RBW6305G11331-3G MAIN GEAR BOX INPUT PINION RING NUT WRENCH

WORK ORDER NON-CONFORMANCE / UPDATE

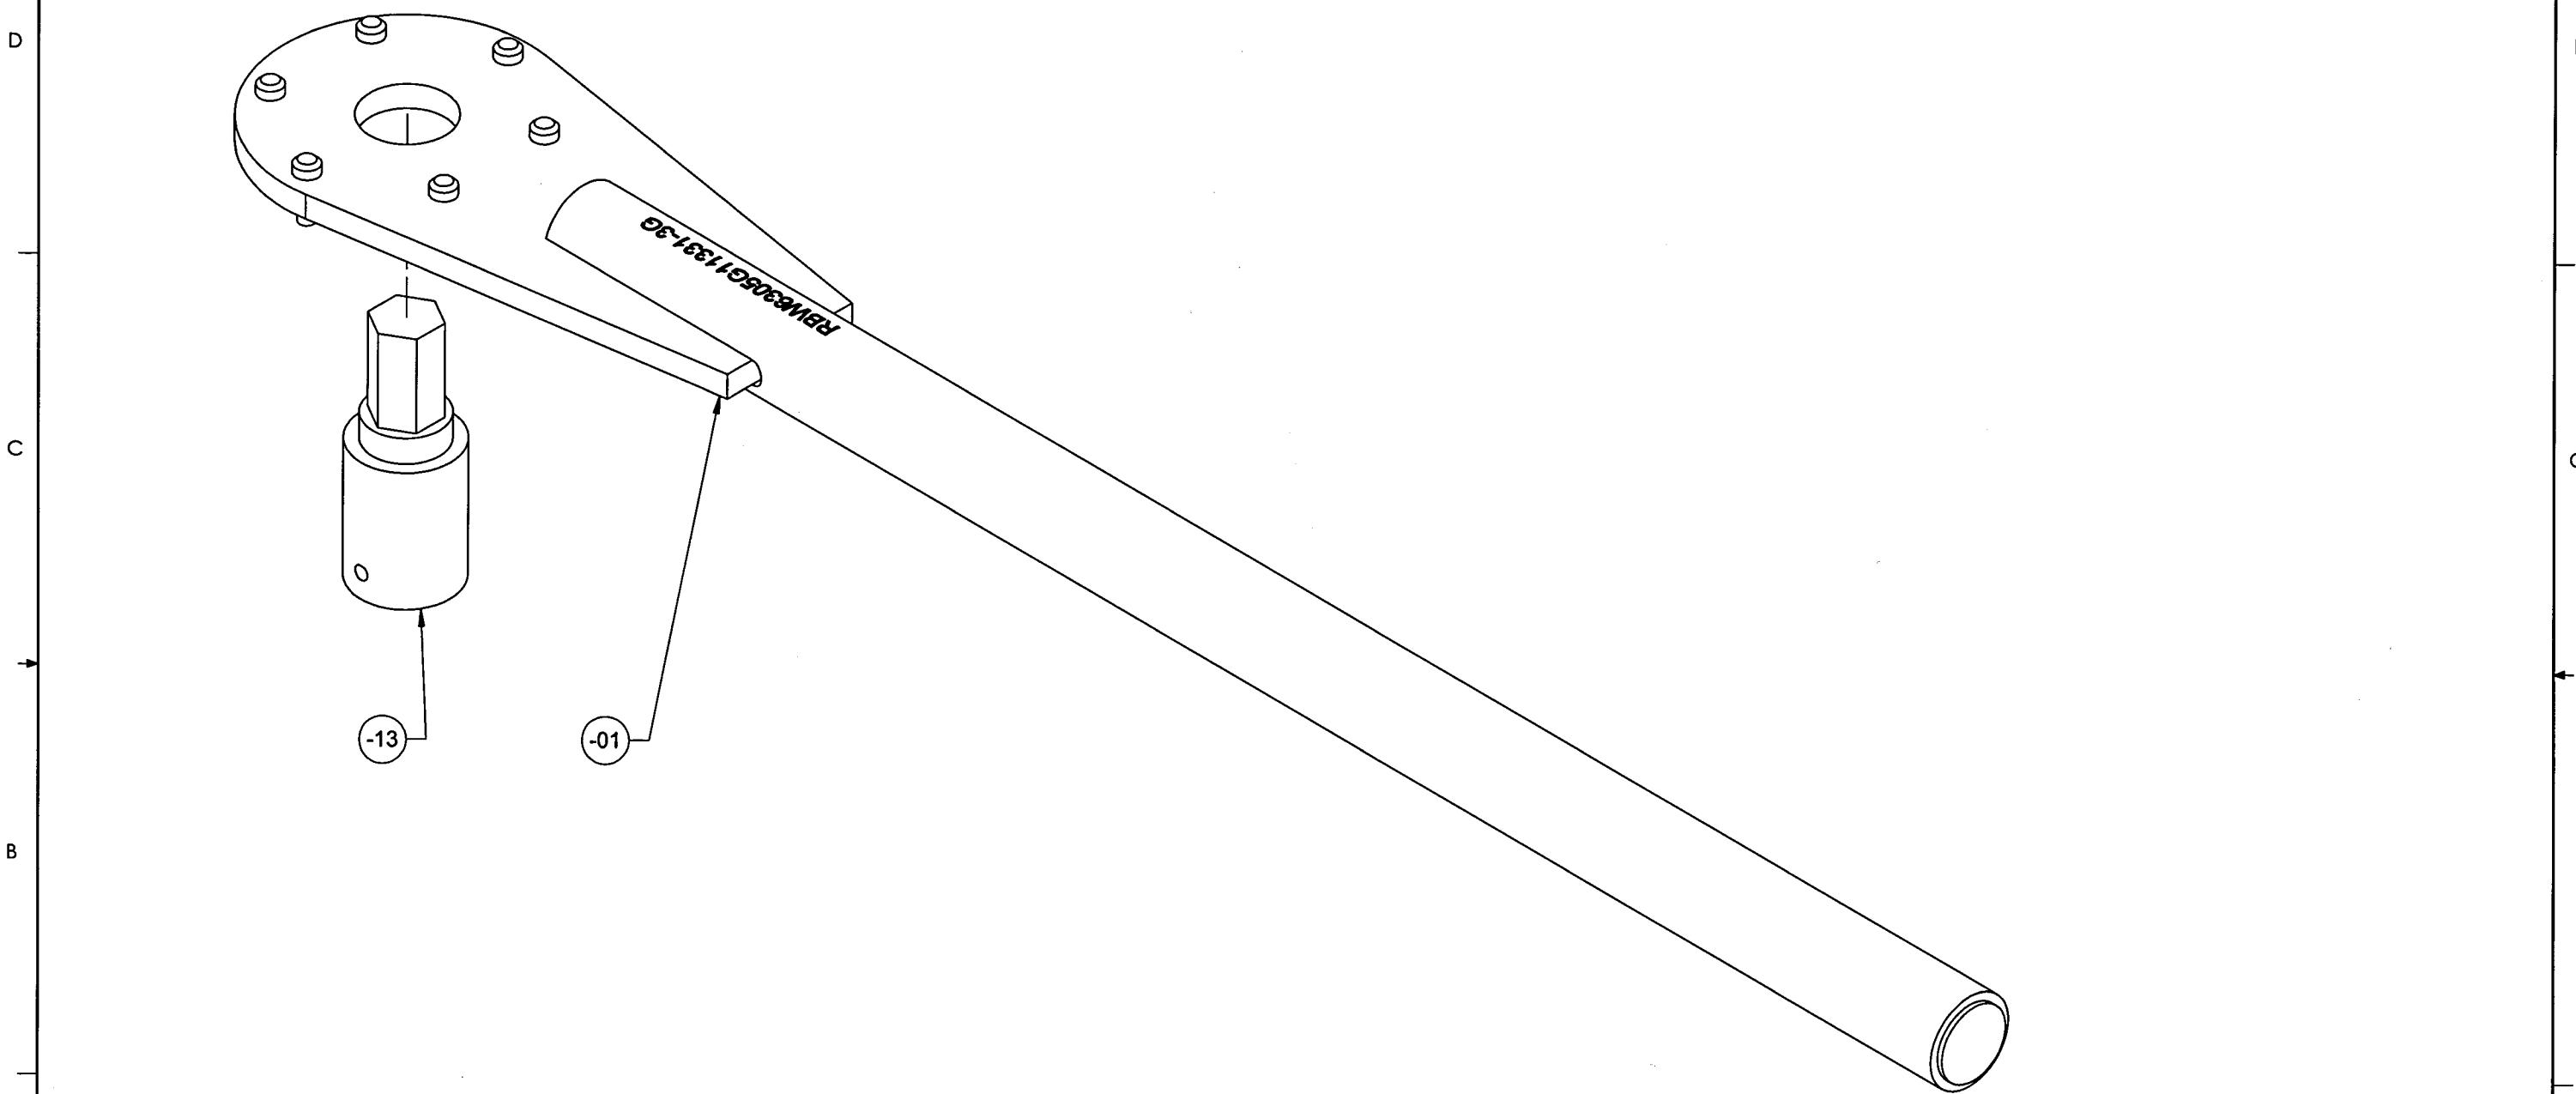
C	ITEM -13 SOCKET ADDED, TEMPLATE UPDATED	18-538	VM
REV.	DESCRIPTION	ECN #	BY
DESIGN	VM	DART AEROSPACE LTD	
DRAWN	VM 04/17/2018	HAWKESBURY, ONTARIO, CANADA	
CHECKED	VM 04/17/2018	TOOL PART #	REV. C
MFG. APPR.	DP 04/18/2018	RBW6305G11331-3G	SHEET 1 OF 8
APPROVED	ML 04/24/2018	TITLE	SCALE
		MAIN GEAR BOX INPUT PINION RING NUT WRENCH	NTS
DATE	4/24/2018	COPRIGHT © 2018 BY DART AEROSPACE LTD	
		THIS DOCUMENT IS PRIVATE AND CONFIDENTIAL AND IS SUPPLIED ON THE EXPRESS CONDITION THAT IT IS NOT TO BE USED FOR ANY PURPOSE OR COPIED OR COMMUNICATED TO ANY OTHER PERSON WITHOUT WRITTEN PERMISSION FROM DART AEROSPACE LTD.

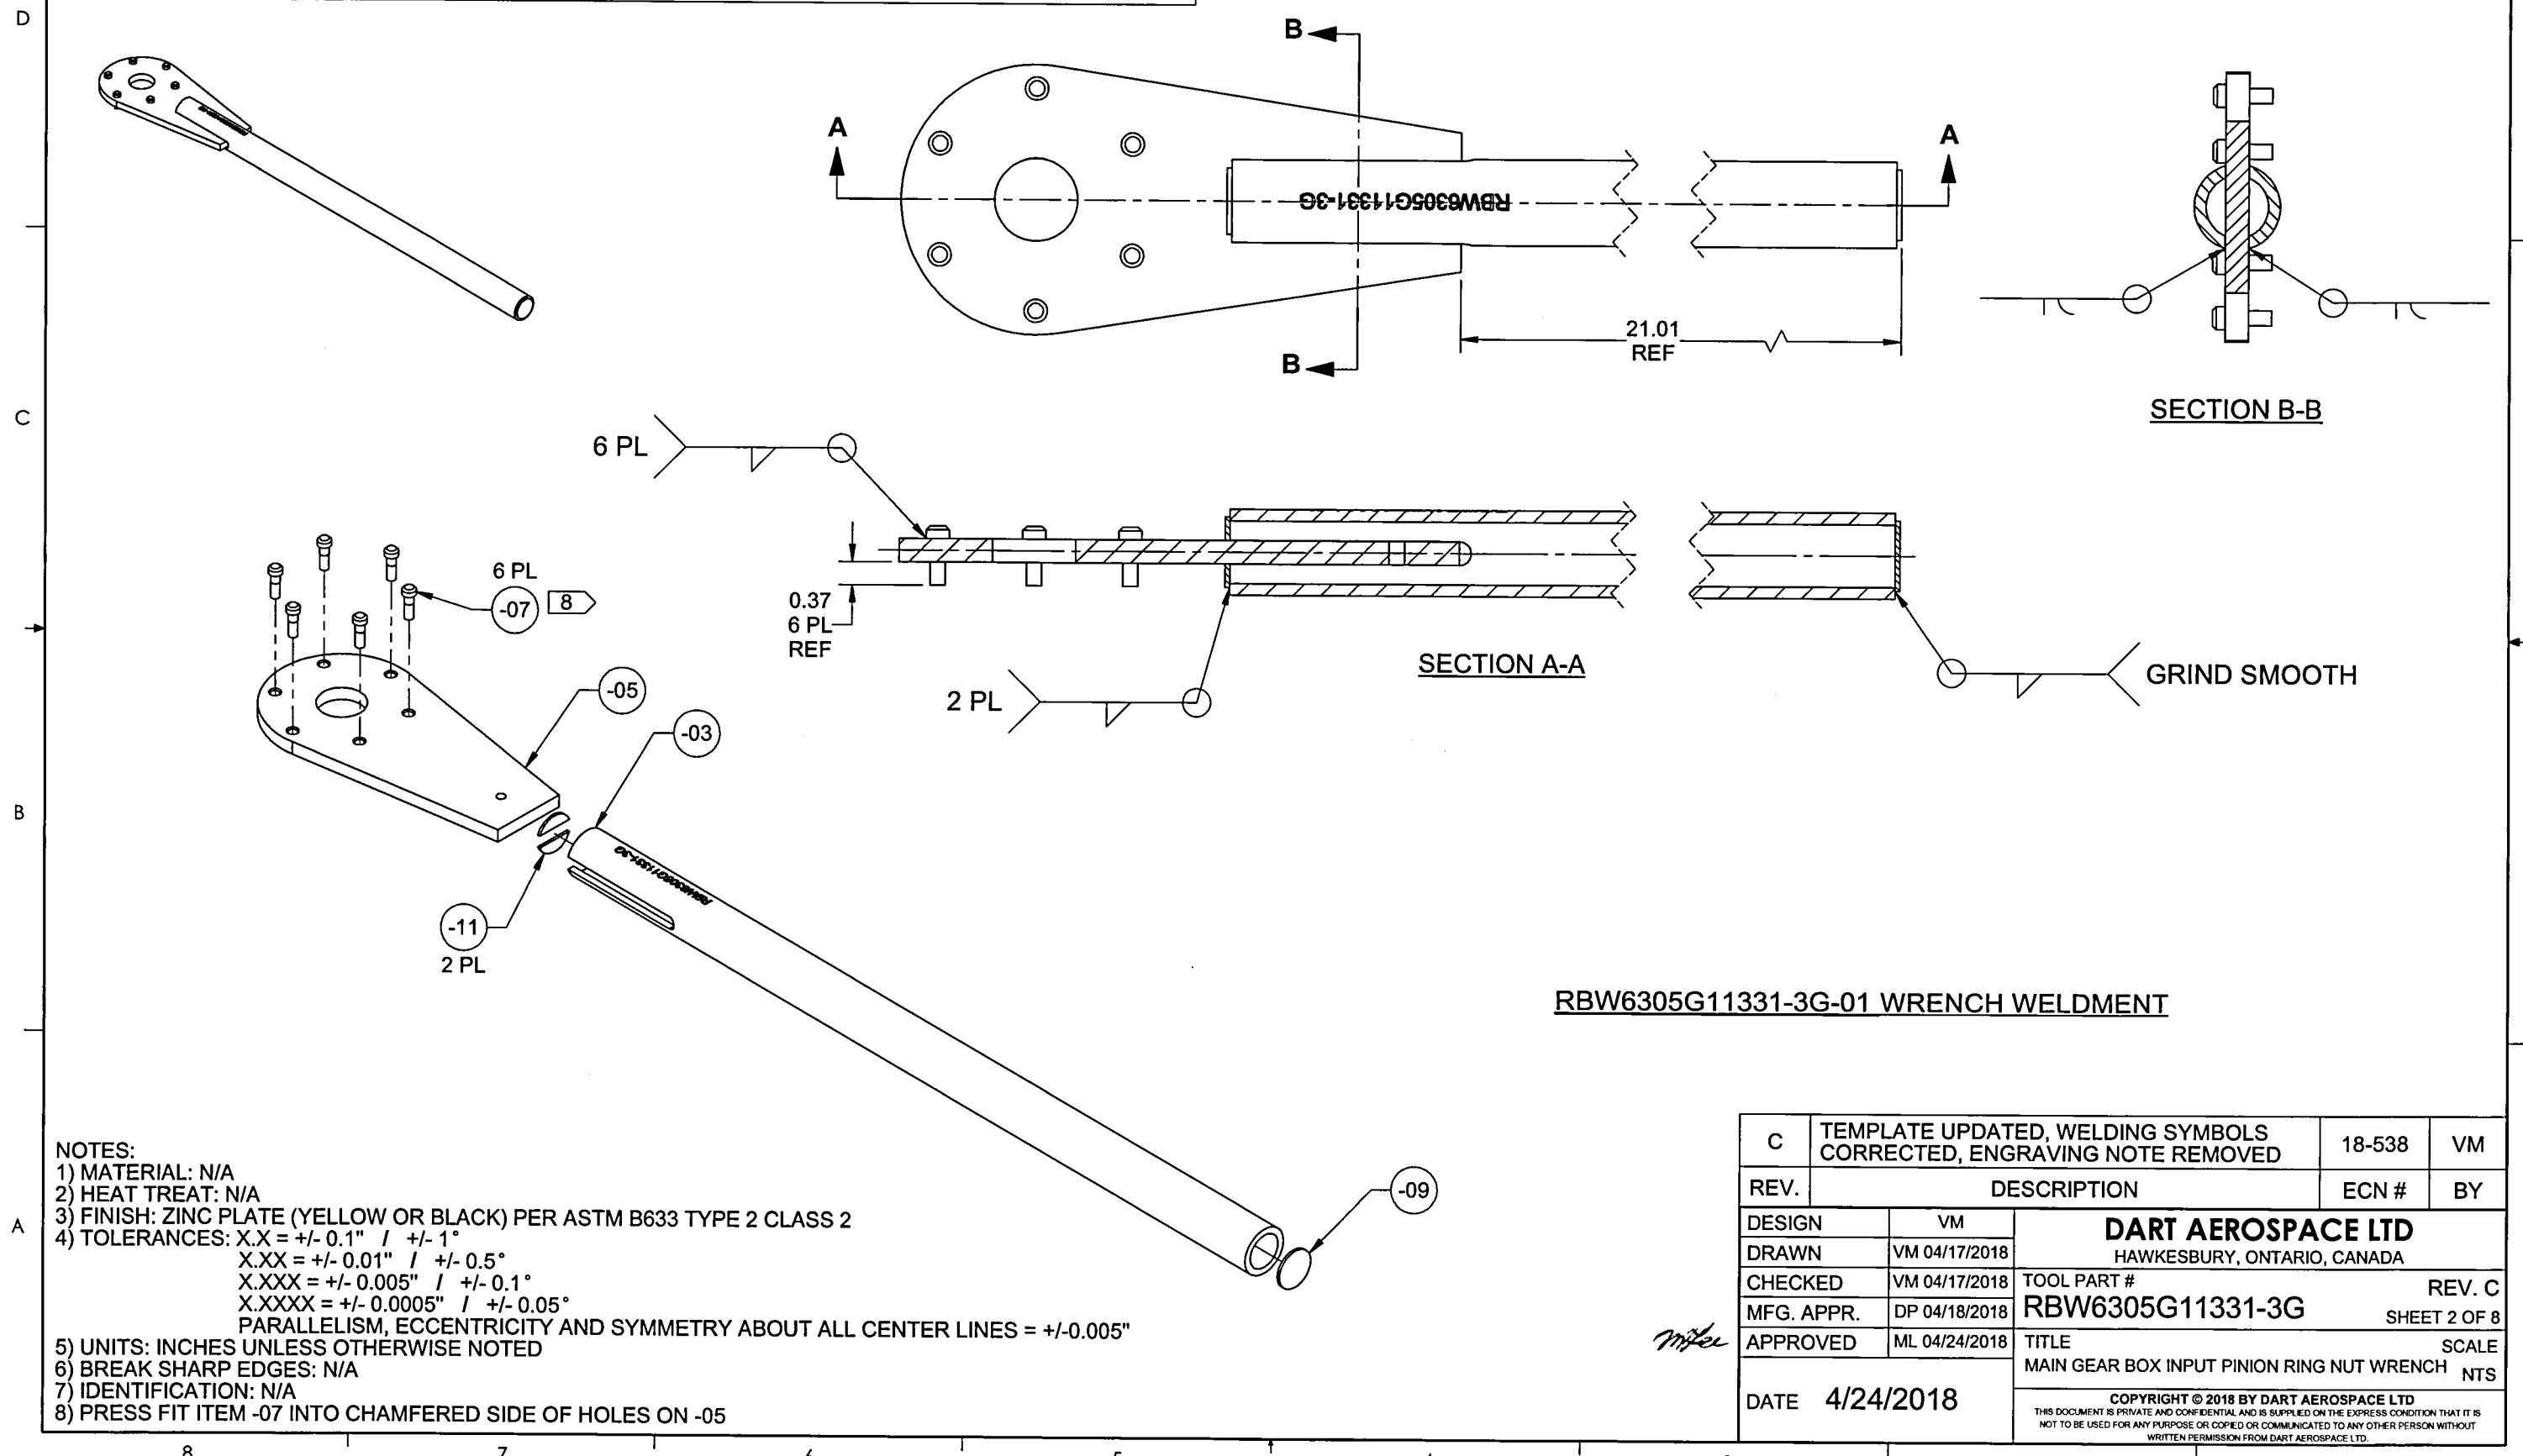
C	TEMPLATE UPDATED, WELDING SYMBOLS CORRECTED, ENGRAVING NOTE REMOVED	18-538	VM
REV.	DESCRIPTION	ECN #	BY
DESIGN	VM		
DRAWN	VM 04/17/2018		
CHECKED	VM 04/17/2018	TOOL PART #	REV. C
MFG. APPR.	DP 04/18/2018	RBW6305G11331-3G	SHEET 2 OF 8
APPROVED	ML 04/24/2018	TITLE MAIN GEAR BOX INPUT PINION RING NUT WRENCH NTS	SCALE
DATE	4/24/2018	COPRIGHT © 2018 BY DART AEROSPACE LTD THIS DOCUMENT IS PRIVATE AND CONFIDENTIAL AND IS SUPPLIED ON THE EXPRESS CONDITION THAT IT IS NOT TO BE USED FOR ANY PURPOSE OR COPIED OR COMMUNICATED TO ANY OTHER PERSON WITHOUT WRITTEN PERMISSION FROM DART AEROSPACE LTD.

RBW6305G11331-3G-05 PLATE

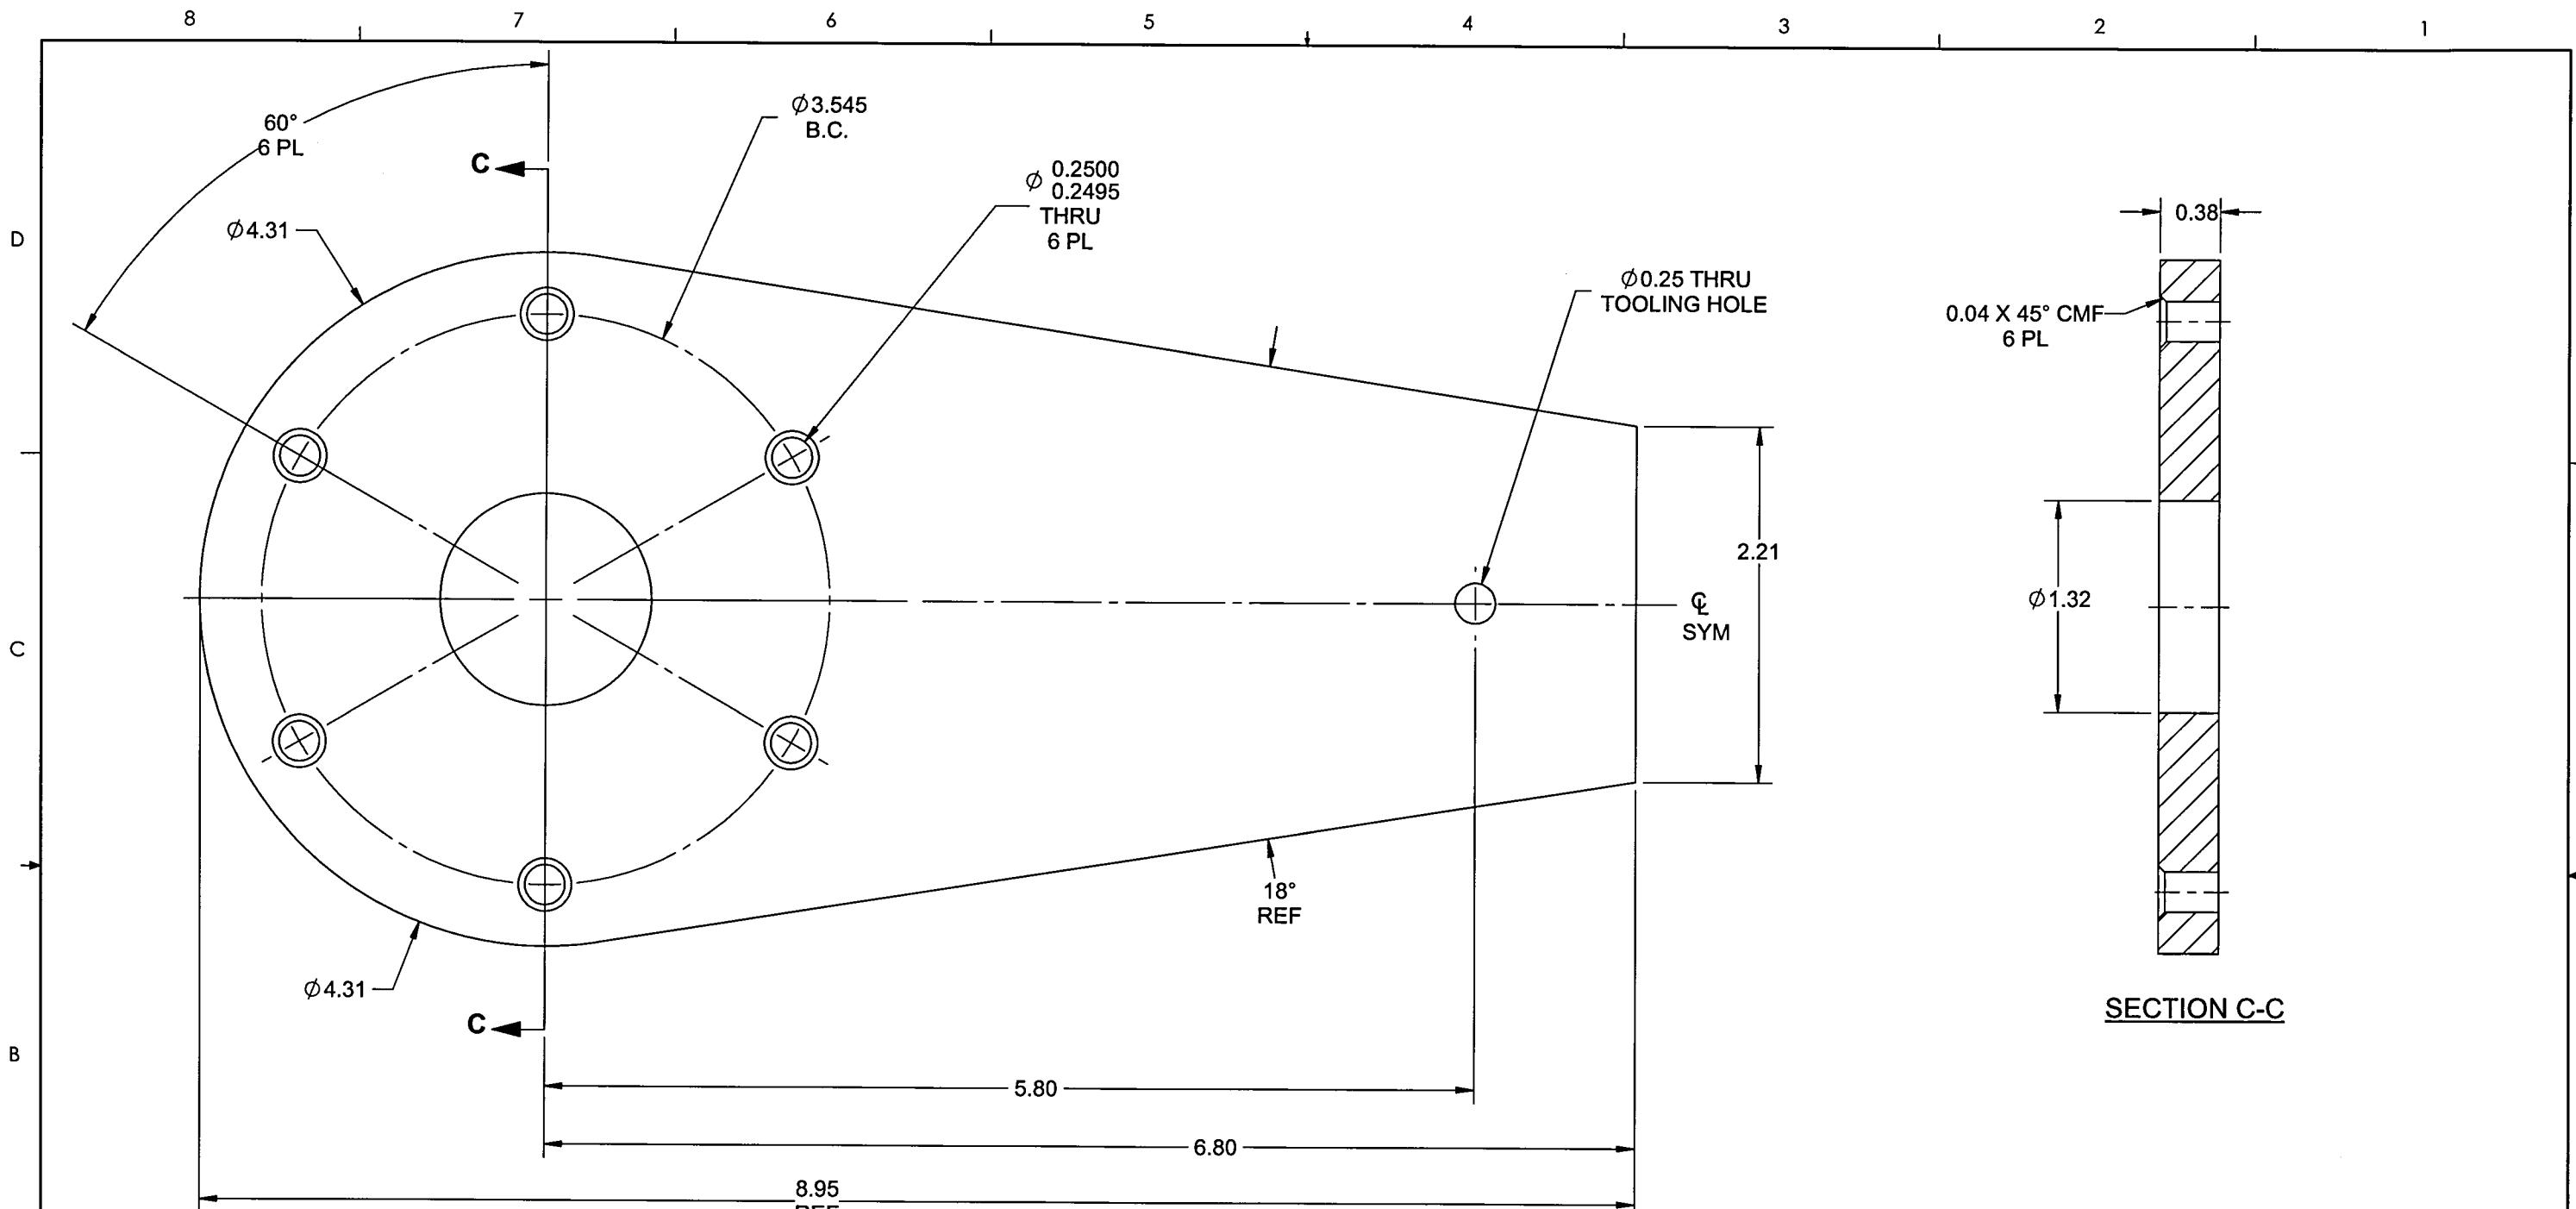
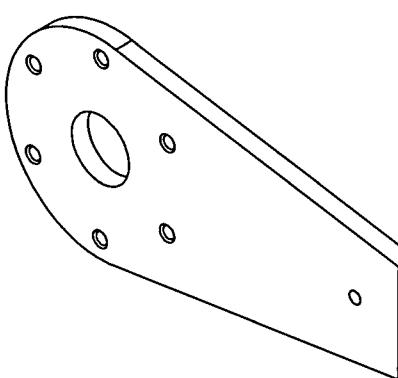
C	TEMPLATE UPDATED, DIMENSION 3.545 B.C ADDED, SYMBOL CL SYM ADDED, DIMENSION 8.95 CHANGED FOR REF AND DIMENSION 6.80 ADDED			18-538	VM
REV.	DESCRIPTION			ECN #	BY
DESIGN	VM	DART AEROSPACE LTD HAWKESBURY, ONTARIO, CANADA			
DRAWN	VM 04/17/2018				
CHECKED	VM 04/17/2018	TOOL PART #		REV. C	
MFG. APPR.	DP 04/18/2018	RBW6305G11331-3G		SHEET 4 OF 8	
APPROVED	ML 04/24/2018	TITLE		SCALE	
		MAIN GEAR BOX INPUT PINION RING NUT WRENCH		NTS	
DATE 4/24/2018		COPYRIGHT © 2018 BY DART AEROSPACE LTD THIS DOCUMENT IS PRIVATE AND CONFIDENTIAL AND IS SUPPLIED ON THE EXPRESS CONDITION THAT IT IS NOT TO BE USED FOR ANY PURPOSE OR COPIED OR COMMUNICATED TO ANY OTHER PERSON WITHOUT WRITTEN PERMISSION FROM DART AEROSPACE LTD
